From: Dr. Max Lee
To: Subramaniam, Pawan
Cc: Linero, Alvaro; gtownsend@cemexusa.com; jdaniel@cemexusa.com
Subject: 307-15-02 307-15-03 FW: 0530021-053-AC-PSD-91M, CEMEX Construction Materials Florida, LLC, Brooksville South Cement Plant, Draft Permit
Date: Monday, April 06, 2015 4:48:02 PM
Attachments: image001.png
0530021-053-AC - Written Notice_signed.pdf
0530021-053-AC - Public Notice.docx

0530021-053-AC – Kiln 1

0530021-052-AC – Kiln 2

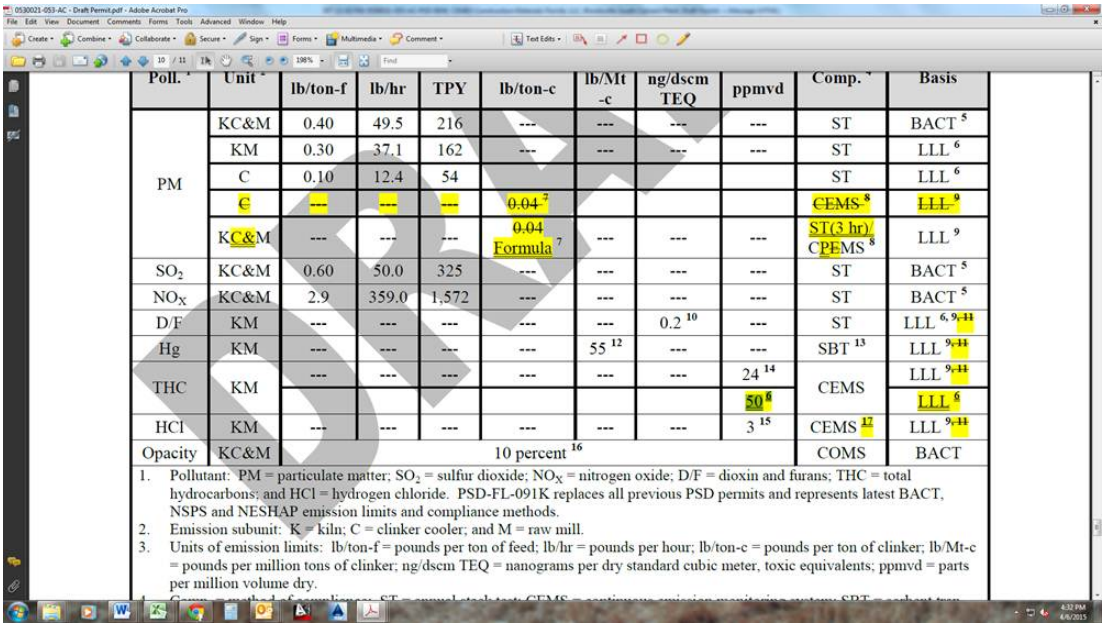
The primary issue of concern is on page 10 of 11 where the revisions proposed for AC permit 043-AC state NESHAP THC limit must be compiled with (50 ppmvd by CEMS until 9/9/15). Screenshot below.

Similar to the Miami Cemex kiln which is not subject to this NESHAP limit, that limit applies only to new (greenfield kilns) built after March 24, 1998.

So please confirm for me by email response that the 50 ppmvd limit and related monitoring prior to 9/9/15 is not required and revise the proposed 043-AC permit revisions.

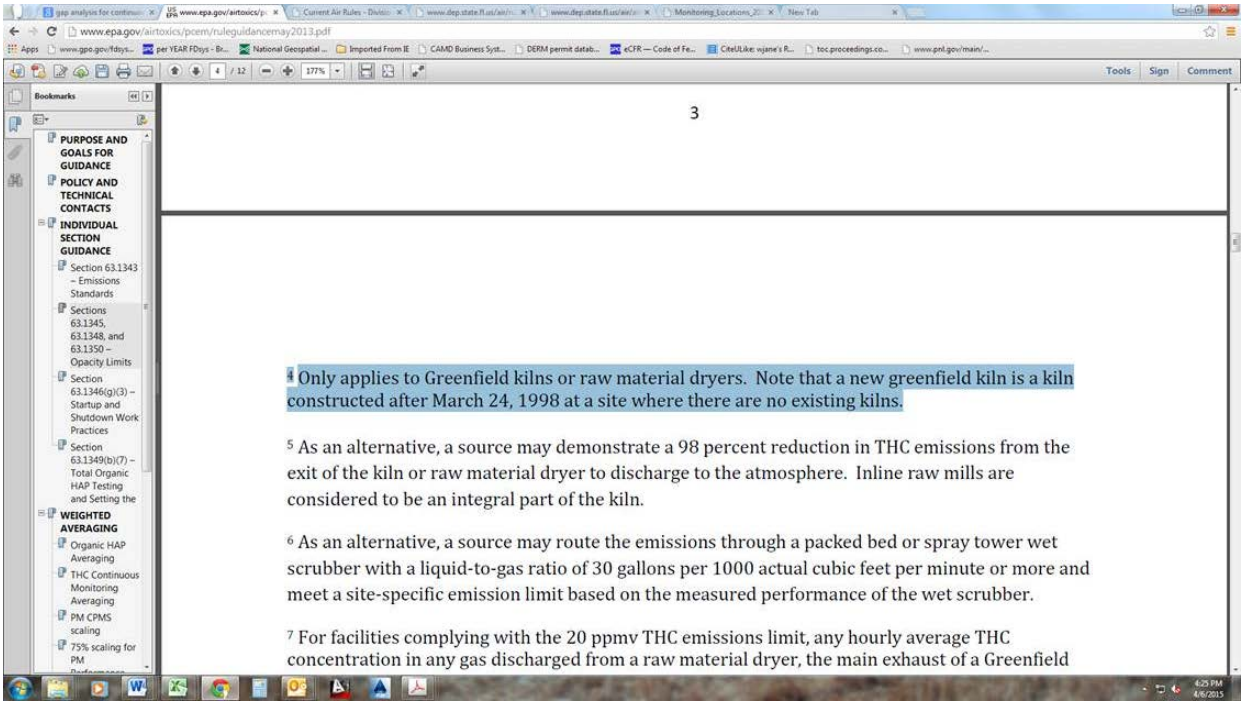
There is a good guidance on this issue at http://www.epa.gov/airtoxics/pcem/ruleguidancemay2013.pdf that can be used to track back to the 1999 initial NESHAP rule.

As well, I have screen shot the document with a highlight below.

[4] Only applies to Greenfield kilns or raw material dryers. Note that a new greenfield kiln is a kiln constructed after March 24, 1998 at a site where there are no existing kilns.
